VEHICLE SAFETY DEFECT  
INITIAL INFORMATION REPORT  
F355 POWER STEERING COLUMN CONNECTION  
RECALL No. 163

REF. NO. 163  
POWER STEERING COLUMN  
CONNECTION  
F 355

## RECALL CAMPAIGN NO. 163

## INSTRUCTIONS FOR THE POWER STEERING COLUMN CONNECTION

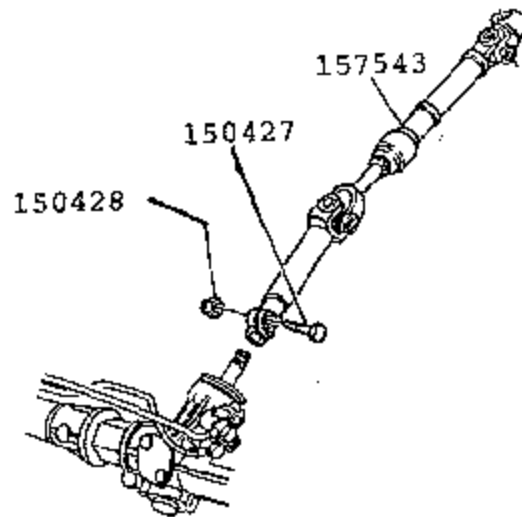
**CONDITION :** The torque of the power steering column nut may be insufficient. Should such a condition occur, impairment of the vehicle handling may result.

- 1) Check the alignment and positioning of the splines on the steering column extension (Part Number 157543) Adjust if necessary.
- 2) Check the correct tightening of the nut/bolt (Part Numbers 150427 / 150428) applying the tightening torque of 23 Nm.

**NOTE: FOR IDENTIFICATION PURPOSES, PLEASE PAINT THE NUT (PART NUMBER 150427) WITH YELLOW PAINT.**
